ECE/TRANS/WP.29/2009/92  
31 July 2009

World Forum for Harmonization of Vehicle Regulations

Proposal for Corrigendum 1 to Revision 2 to Regulation No. 87  
(DRL)

Figure 1"

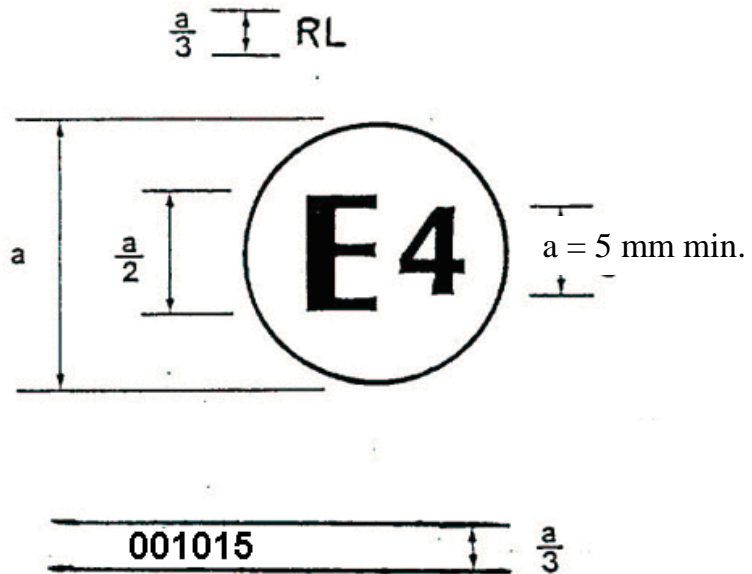
Figure 1, amend to read:
